Oregon Schools Seismic Feedback Form

Benton County (Philomath) School District 17J

RE: Philomath Middle School Seismic Evaluation

PHILOMATH MIDDLE SCHOOL
 2021 CHAPEL DRIVE
 PHILOMATH, OREGON 97370

EXISTING WALL TYPES

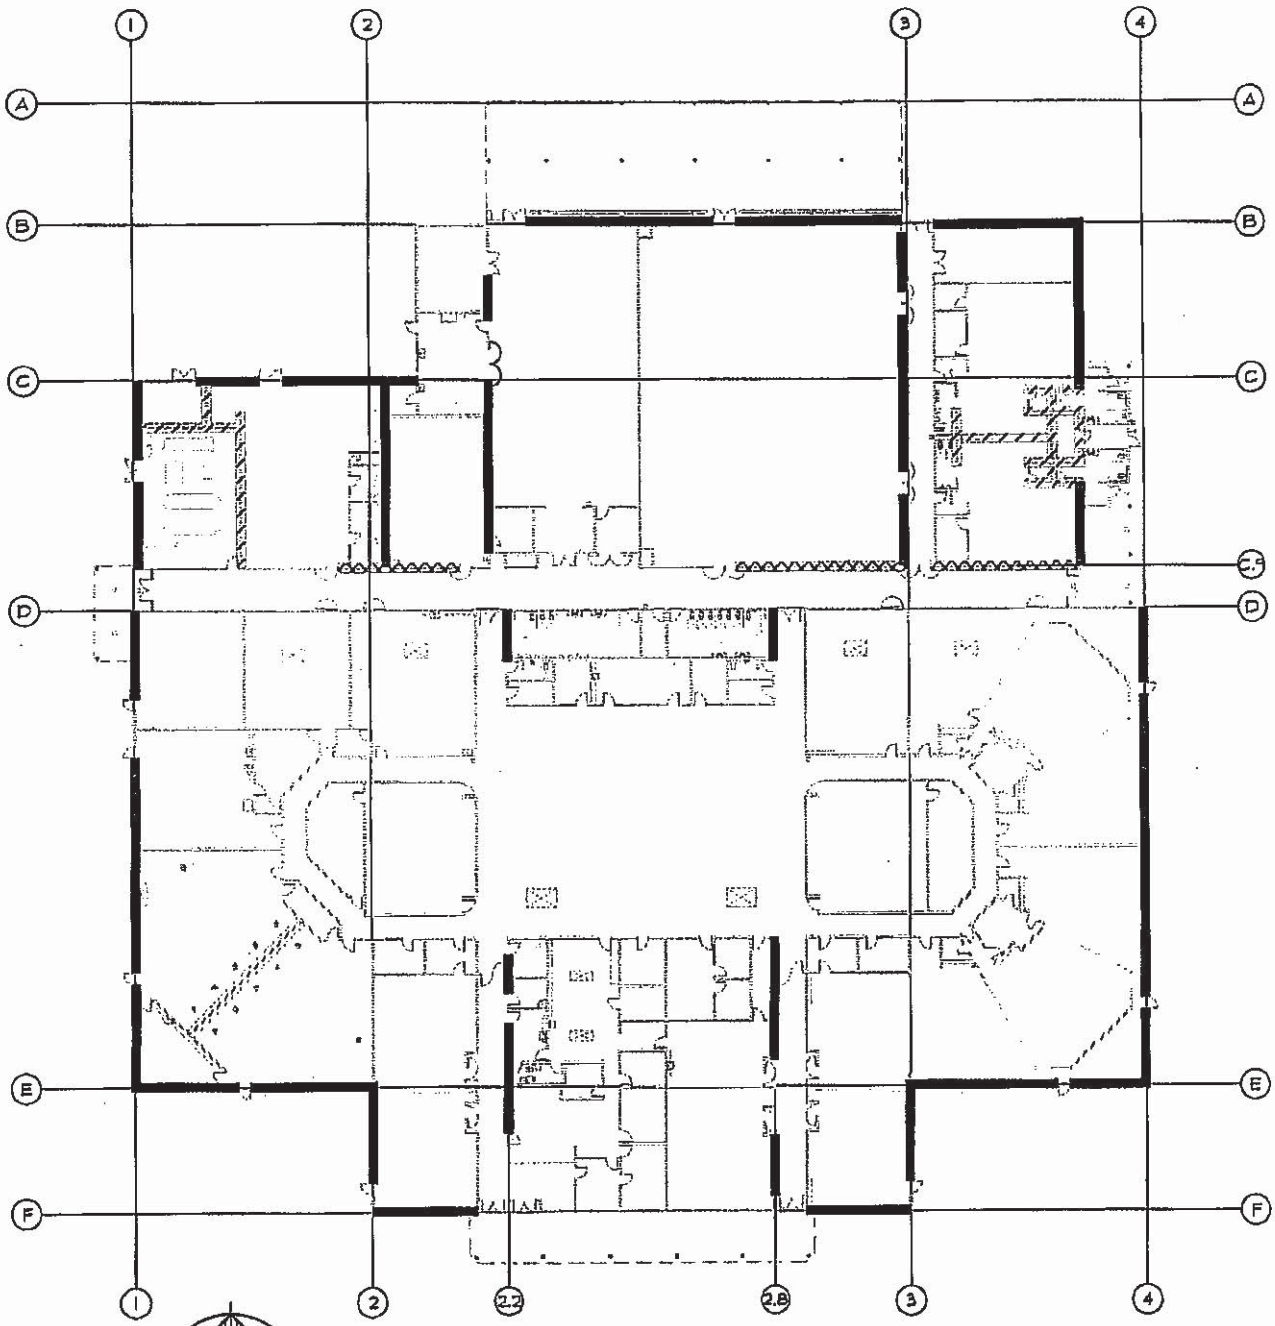
3. In the event of a code level earthquake, most of the wood shear walls in the building would receive more load than their allowable capacities. The shear wall lines at grids B, F, 1, 3 and 4 have adequate shear capacity to meet the code required loads, but the other wall lines do not. The overstressed walls typically have between 60% and 80% of the code required shear capacity. The drawings did not indicate that holdowns were used at any of the shear walls in this building. Many shear walls, particularly walls running in the east-west direction require light to medium capacity holdowns with up to a 6250 lbs uplift capacity. At the walls with higher uplift loads, it is possible that the foundations do not have an adequate capacity for a code level earthquake, but we can not accurately evaluate the foundations without knowing the allowable soil bearing pressure for the soil. This would require an evaluation and report from a geotechnical engineer. For the purpose of our analysis, it was assumed that a shear wall line exists at grid 3.9. Without a shear wall line at either grid 3.9 and/or 4, the shear walls at grids C and E would be greatly overstressed. As it is, there are extensive gypsum sheathed bearing walls at grids 3.9 and 4 that will provide a significant amount of shear resistance, though not enough to meet current code loads.

- A. There are several upgrades that should be made to the existing wood sheathed shear walls (item #3 previously noted). At locations where the existing walls are overstressed, either the nailing of existing wall sheathing will need to be increased or new shear wall sheathing added on the other side of the wall. Additional wall sill plate anchor bolts will be needed and new holdowns will need to be installed. New posts will need to be installed inside the walls at holdown locations and new studs will need to be installed at shear walls that require heavy nailing. This can be problematic at locations with existing electrical conduit, plumbing or other similar things inside the wall. Extensive removal and replacement of wall finishes on one side of shear walls will be required. As was noted previously, the existing bearing walls at either grid 3.9 or 4 will need to be upgraded with new wood sheathing and holdowns.

TYPICAL EXTERIOR DETAIL

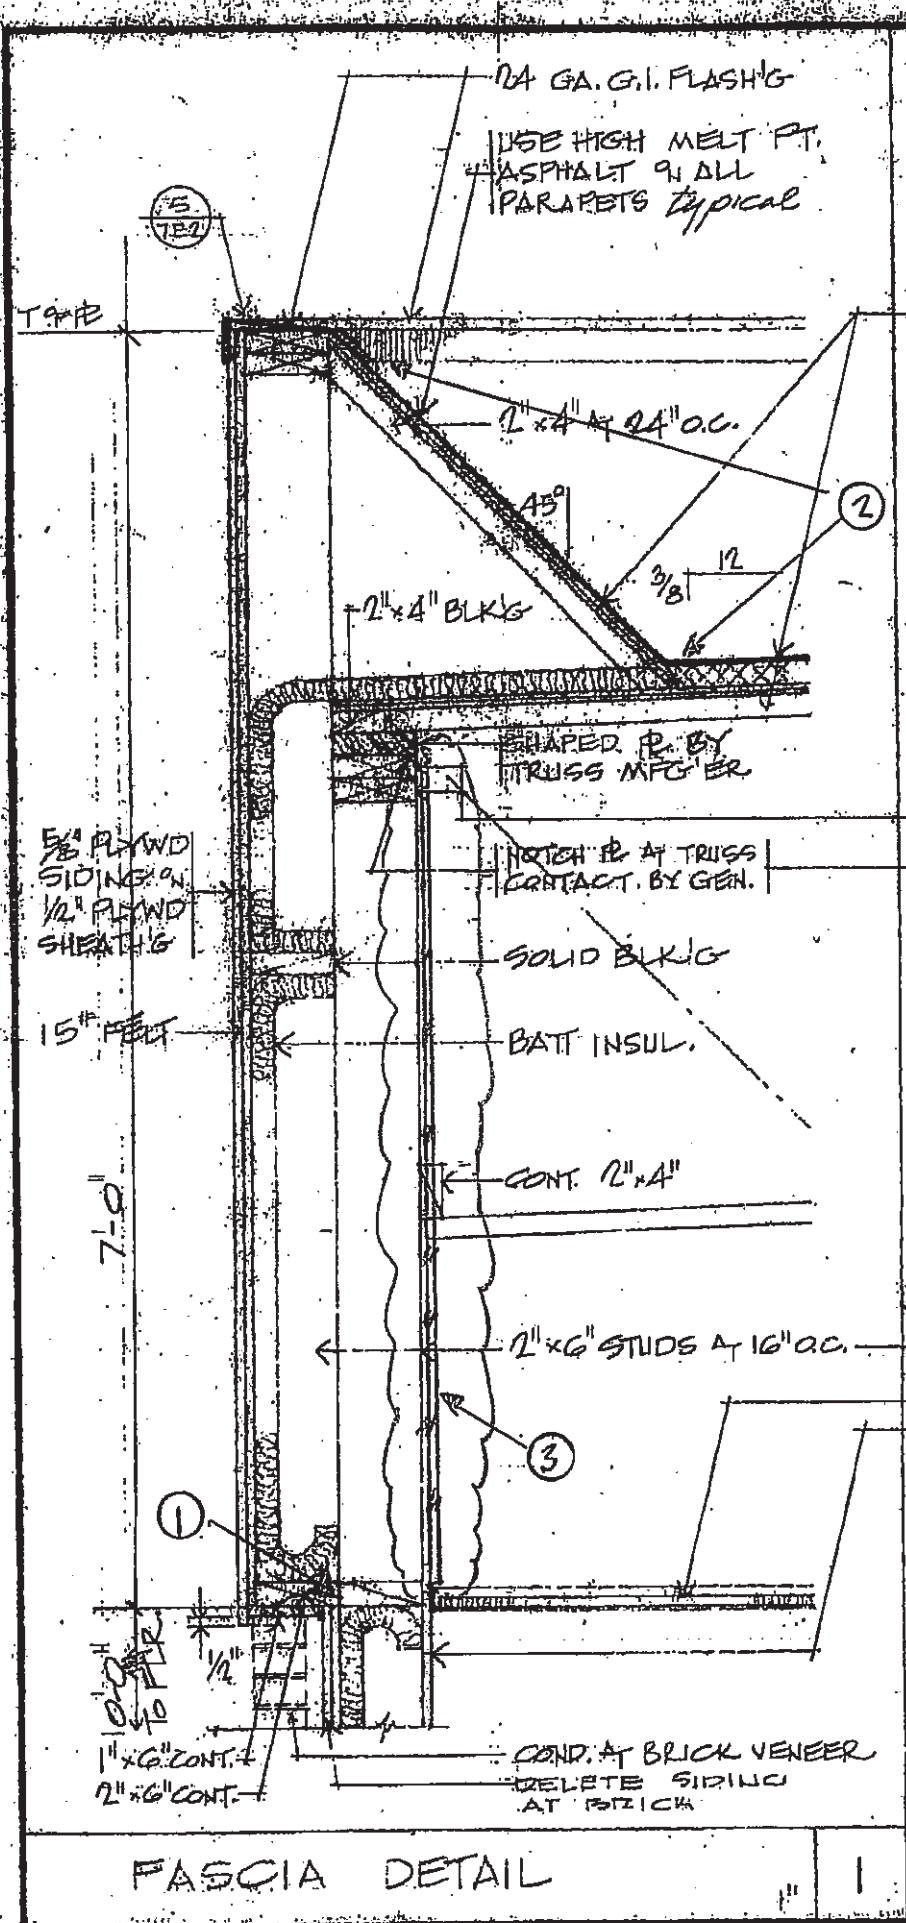
1. The drawings indicate that the original building designers did not provide adequate connections between the shear walls and the roof diaphragm or clearly detailed load paths between the roof and the walls. There are no dedicated collector elements to tie the buildings roof to the shear walls. In an earthquake, the seismic load will be spread out evenly across the roof. A collector element (also sometimes referred to as a drag strut) would be an element like a beam line or wall plate line that would extend across the building that would "collect" the dispersed load and provide a path for the load to reach a shear wall. At exterior shear walls, the shear wall sheathing typically runs continuously up to the bottom of exterior soffits and canopies rather than running continuously up to the roof. Instead, the sheathing bumps out to the edge of the soffit making for a convoluted load path that is not detailed in the drawings. See the marks on a typical exterior detail accompanying this report as an example.

① THE EXISTING SHEAR WALL SHEATHING STOPS AT THE BASE OF THE SOFFIT, THE CONNECTION BETWEEN THE BLOCK AT THE BASE OF THE FASCIA AND THE SHEATHING IS NOT CLEAR.

② THE LOAD PATH FROM THE ROOF TO THE SHEAR WALL SHEATHING IS - FROM THE ROOF SHEATHING TO THE CRICKET SHEATHING - FROM THE CRICKET SHEATHING TO THE FASCIA TOP R. - FROM THE FASCIA TOP R. TO THE FASCIA SHEATHING - FROM THE FASCIA SHEATHING TO THE FASCIA BOTTOM R. - FROM THE FASCIA BOTTOM R. TO THE SHEAR WALL SHEATHING

- B. At the existing perimeter shear walls with offset parapets and soffits, as was noted in item 1, the load path from the roof to the shear wall below is convoluted. We recommend that new shear wall sheathing be installed from where the shear wall sheathing stops below, to the wall top plate. See the accompanying marks noted on an existing wall detail for more information.

③ AS PART OF A FUTURE SEISMIC UPGRADE WE WOULD RECOMMEND THE INSTALLATION OF NEW SHEAR WALL SHEATHING TO THE WALL TOP R.
